STAFF REPORT: 10-9-2019 MEETING
APPLICATION NUMBER: 19-6489
ADDRESS: 90 SEWARD
HISTORIC DISTRICT: NEW CENTER
APPLICANT: BRAIN HURTIENNE
DATE OF COMPLETE APPLICATION: 9/10/2019
DATE OF STAFF SITE VISIT: 10/1/2019

SCOPE: INSTALL NEW BALCONIES

90 SEWARD REHABILITATION

ENLARGED BALCONY PLAN AND BALCONY DETAILS

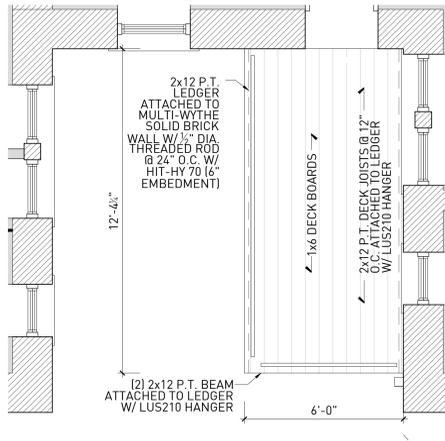
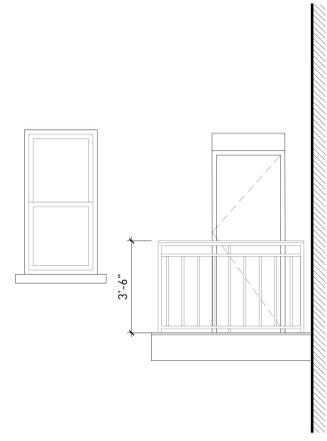
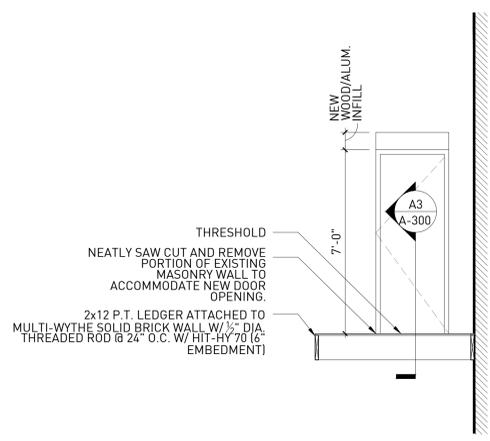
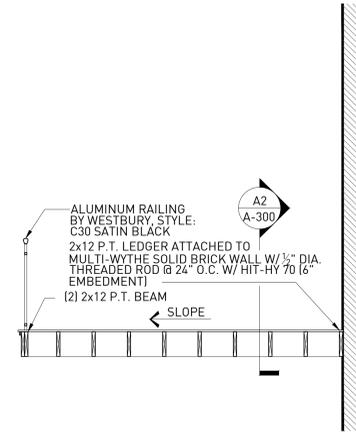
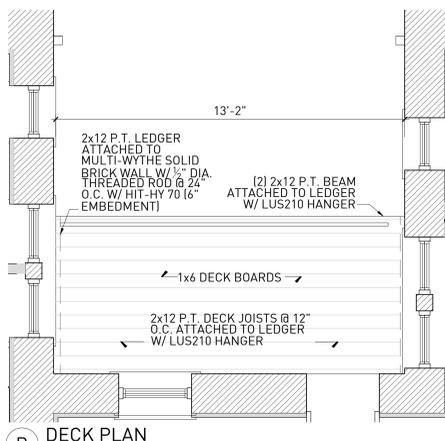
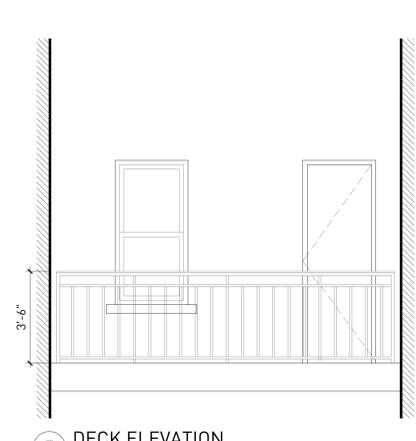
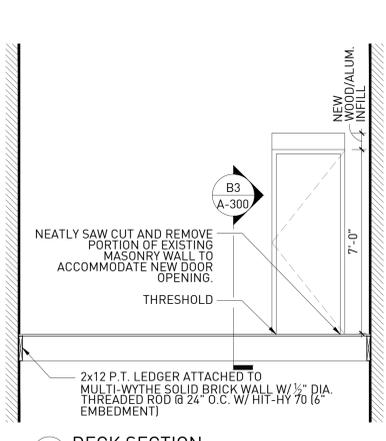
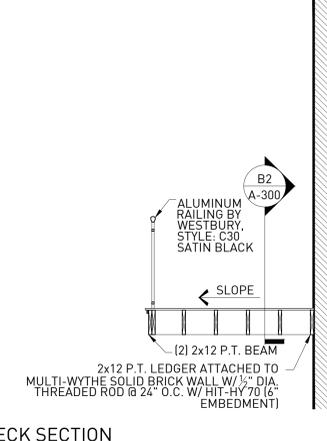
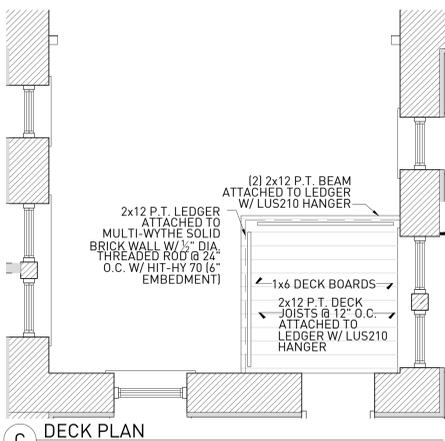
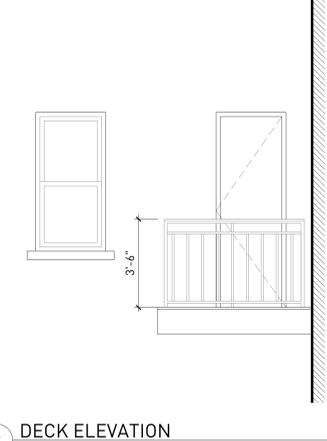
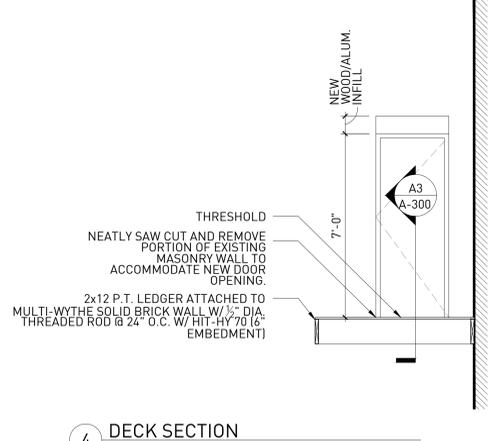
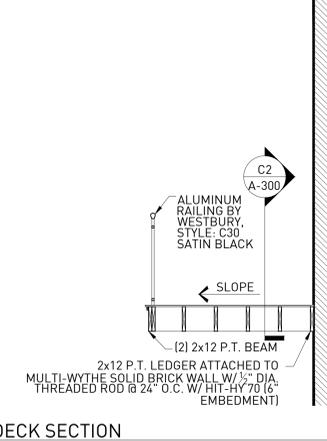
- At each unit, remove one existing window and saw cut brick to lengthen opening in order to accommodate the installation of a new fiberglass single door (color not specified) with glass transom. Each door will lead to a new balcony. The new balcony decks will measure 6'-0" x 12'-4" and will be constructed of wood with wood decking. Each deck will also feature aluminum picket railing which will measure 3'-6" high. The new decks will not be painted.

- The new balconies will not be visible from the public right of-way as they are located within the light wells
- The windows which will be removed and replaced with doorways are not historic age

It is staff's opinion that the work as proposed will not result in the removal of historic materials or the alteration of features and spaces that characterize the property. The work is also compatible with the building's historic character. Staff therefore recommends that the Commission issue a Certificate of Appropriateness for the work as proposed because it meets the Secretary of the Interior Standards for Rehabilitation, standards #2) *The historic character of a property shall be retained and preserved. The removal of historic materials or alteration of features and spaces that characterize a property shall be avoided* and #9) *New additions, exterior alterations, or related new construction shall not destroy historic materials that characterize the property. The new work shall be differentiated from the old and shall be compatible with the massing, size, scale, and architectural features to protect the historic integrity of the property and its environment.* However staff recommends that the Commission issue this COA with the condition that the balconies are either painted or stained a color which matches the buildings trim and that the color of the new fiberglass doors be reviewed and approved by HDC staff prior to the work's initiation.
